STAFF RECOMMENDATION
1808 Ordway Place
January 18, 2012

Application: New Construction—addition
District: Lockeland Springs-East End Neighborhood Conservation Zoning Overlay
Council District: 06
Map and Parcel Number: 08310023800
Applicant: Lynn Taylor
Project Lead: Melissa Baldock, melissa.baldock@nashville.gov

<p>Description of Project: Construct new front porch and rear addition to a non-contributing structure.</p> <p>Recommendation Summary: Staff recommends approval of the project with the following conditions:</p> <ol style="list-style-type: none"> 1. Staff review and approve a brick sample, the color of the asphalt shingle roof, and all windows and doors prior to purchase and installation; 2. The applicant submit for staff’s approval a site plan showing the footprint of the new driveway. <p>With these conditions, staff finds the proposed project to meet Section II.B. of the <i>Lockeland Springs-East End Neighborhood Conservation Zoning Overlay: Handbook and Design Guidelines</i>.</p>	<p>Attachments A: Photographs B: Site Plan C: Elevations</p>
--	--

FRONT ELEVATION

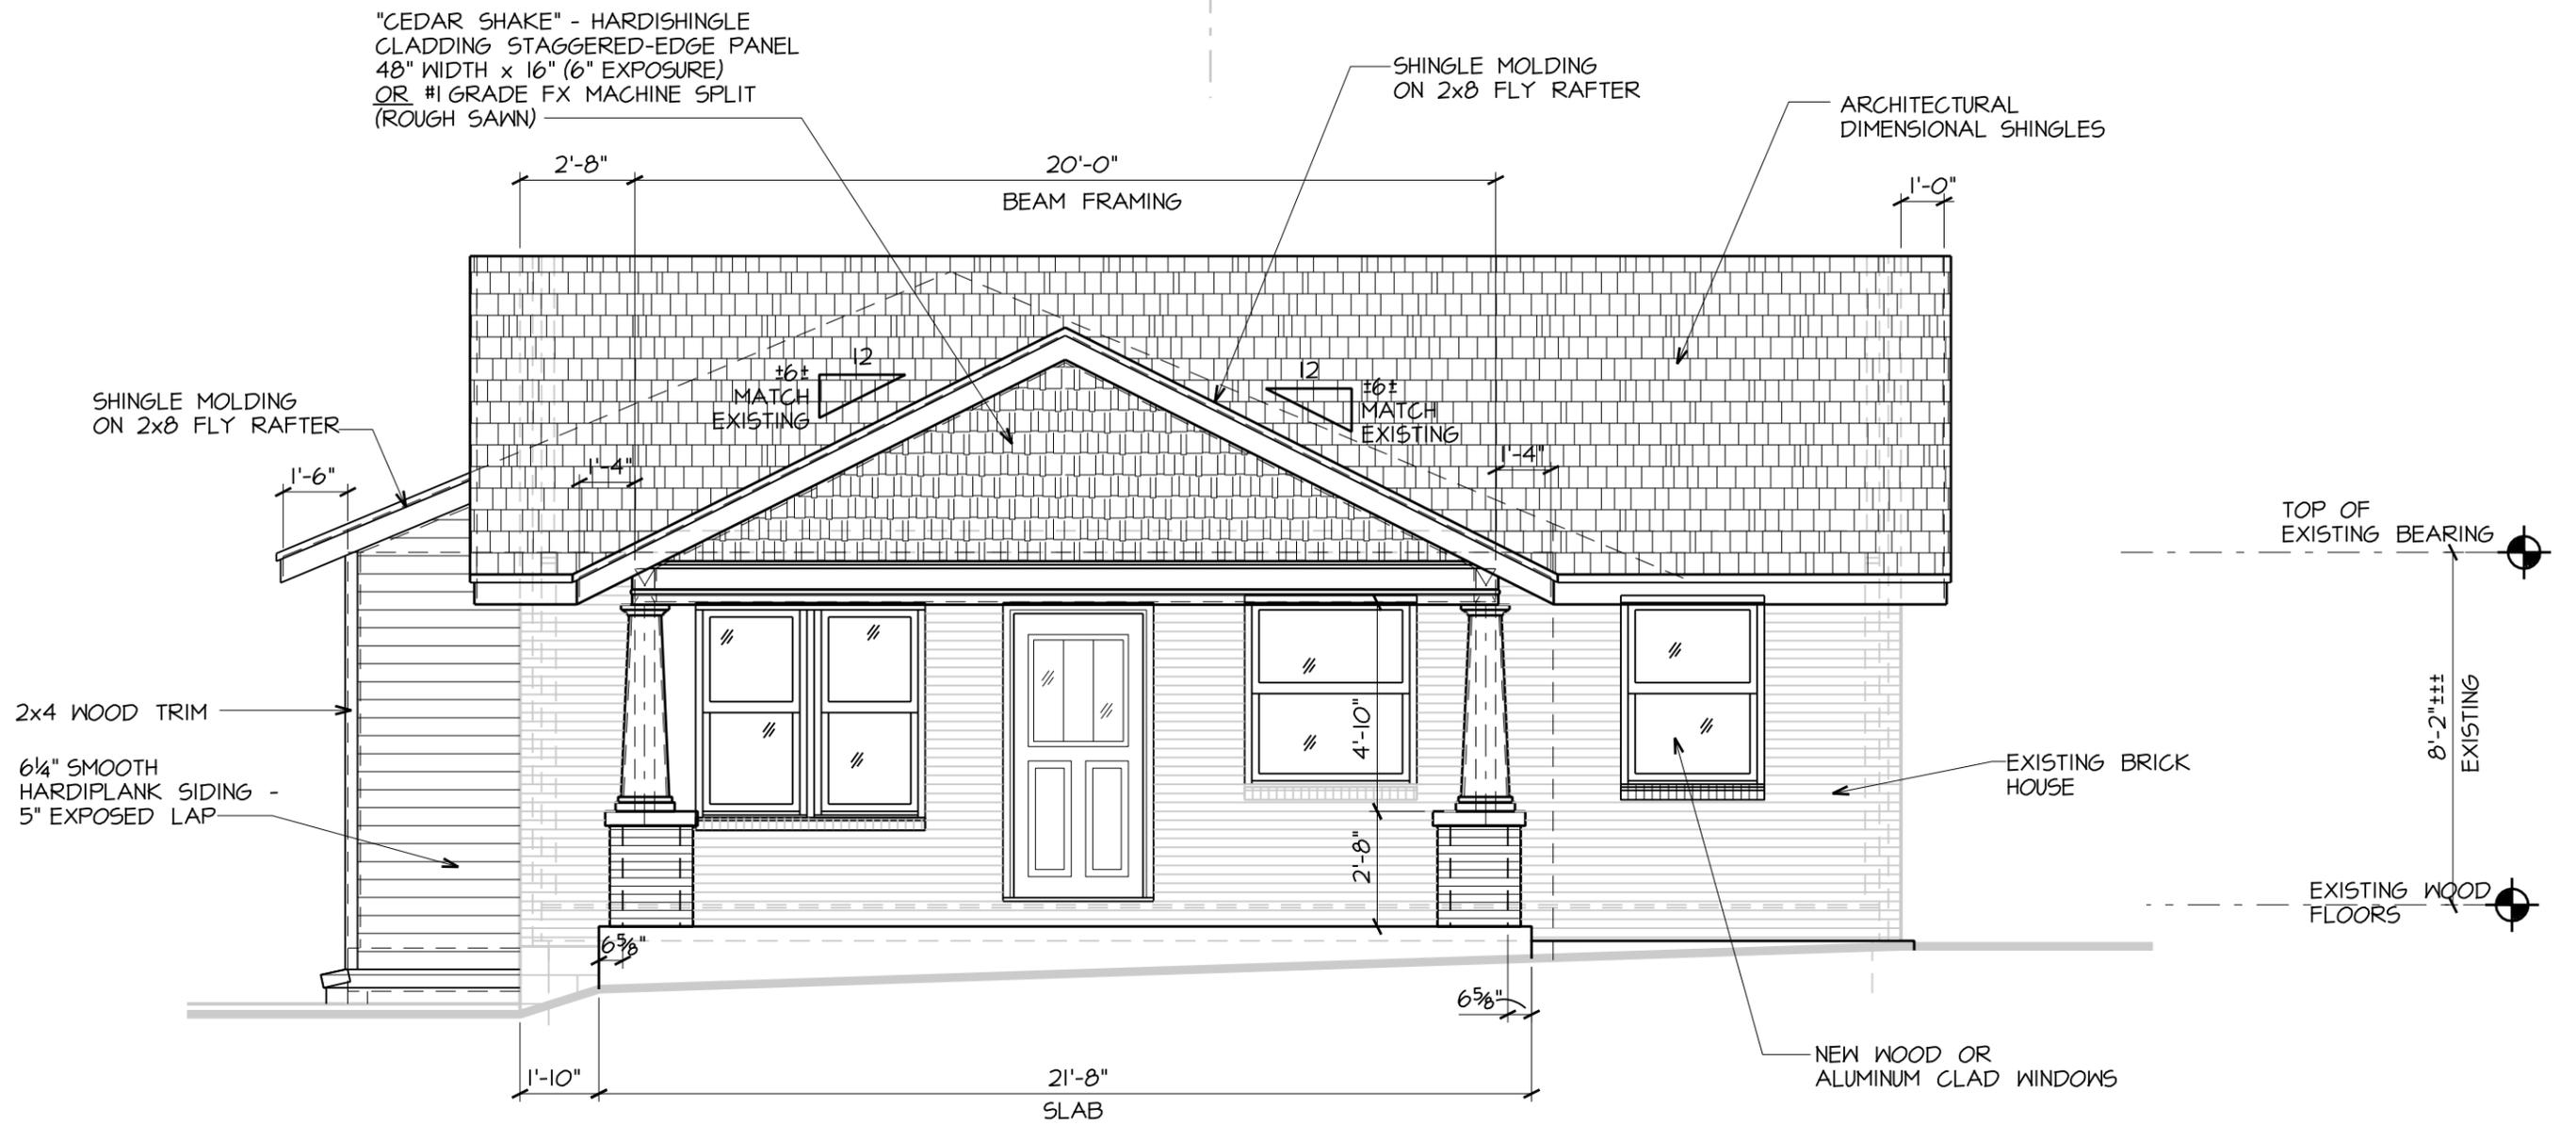
Location and Setback: On the front façade, a new porch that is six-feet, seven inches (6'7") deep and twenty-one feet, eight inches (21'8") wide will be constructed. It is located slightly off center, but is centered on the existing doorway. Adding on to the front of the house is appropriate because this is a non-contributing structure. The addition of the porch will bring the house closer to the sidewalk. With the porch, the house will be about twenty-three feet (23') from the front property line. An examination of the vicinity map shows that the front setbacks on the south side of this block of Ordway range from approximately nineteen feet (19') to twenty-nine feet (29') and that the proposed front setback of twenty-three feet (23') is approximately the average front setback on the block.

Height & Scale: The porch height and scale are appropriate to the size of the house. The house is thirty-two feet (32') wide and twenty-six feet (26') deep. The porch will be six feet, seven inches (6'7") deep and twenty-one feet, eight inches (21'8") wide. The eave height of the porch will match that of the house and will be between eight and nine feet (8'-9') because of the slope of the site. The ridge height of the front-gabled porch will be approximately fifteen feet (15'), approximately one foot, eight inches (1'8") lower than the ridge of the house.

Roof: The existing house has a side gabled roof with a slope of approximately six-twelve (6/12). The proposed front porch will have a front-gabled roof form that will match the existing cross-gable, which has a slope of approximately six-twelve (6/12). The rear addition will have a front-gabled roof with a slope of five-twelve (5/12). The lower level is treated like a basement level with no eaves or detailing. The upper story is treated like the first floor of an addition. Staff finds the roof forms of the front porch and the rear addition to be appropriate.

Proportion and Rhythm of Openings: The addition does not contain any areas with large expanses lacking a window or door opening. On the front façade, the window pattern will remain largely the same as is existing, except that the window opening on the right will be enlarged. On the right side of the existing house, a door opening will be converted into a window opening, which is appropriate since this is a non-contributing house. On the left side of the existing house, two window openings will be created at the basement level. The window and door openings are appropriately scaled to the house and staff finds that they meet the design guidelines.

REAR ELEVATION

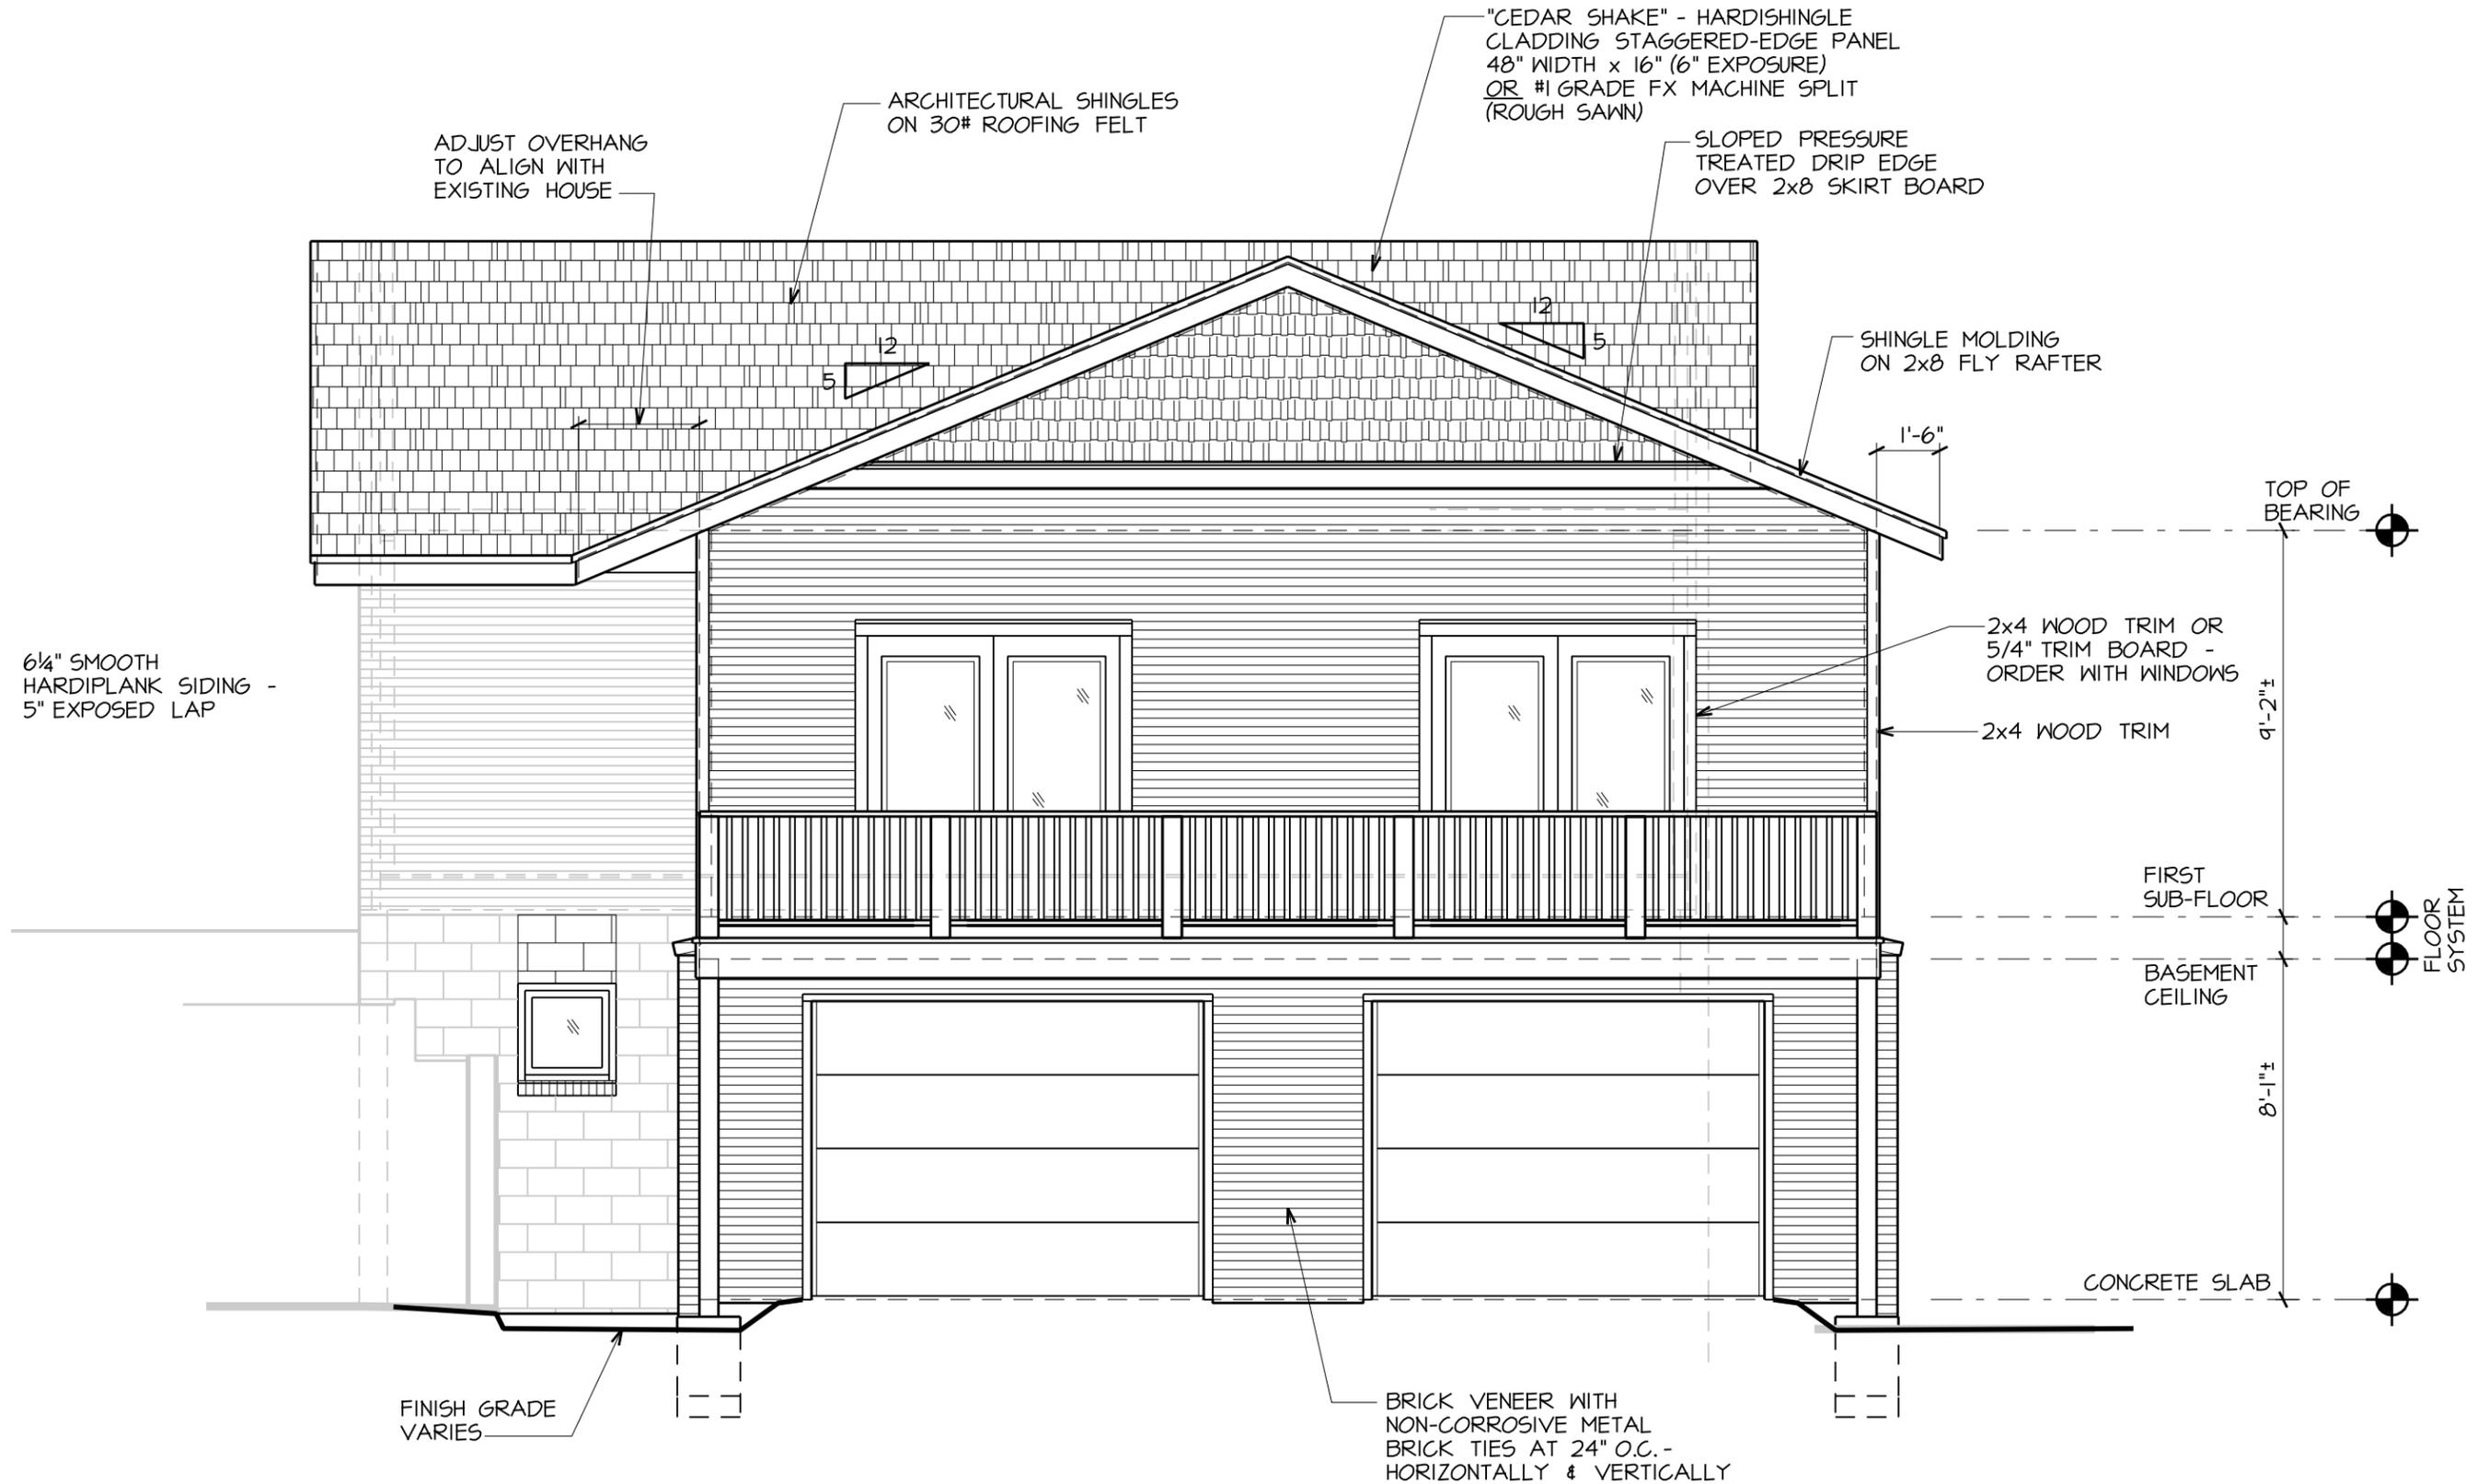
The rear addition will have a depth of thirty feet (30') and a maximum width of twenty-eight feet (28'). Due to the large size of the lot and the fact that this existing structure is

non-contributing, the scale of the addition is appropriate. The site slopes steeply in the rear yard, and there are existing retaining walls on the right and left sides that allow the yard to flatten out in the rear. Because of the slope, the rear addition is two stories, but lower in height than the existing one-story house. The eave of the second story matches the eave height of the house, and the ridge height will be a maximum of approximately twenty-four feet, three inches (24'3"), which is about four inches (4") lower than the ridge height of the house in the rear.
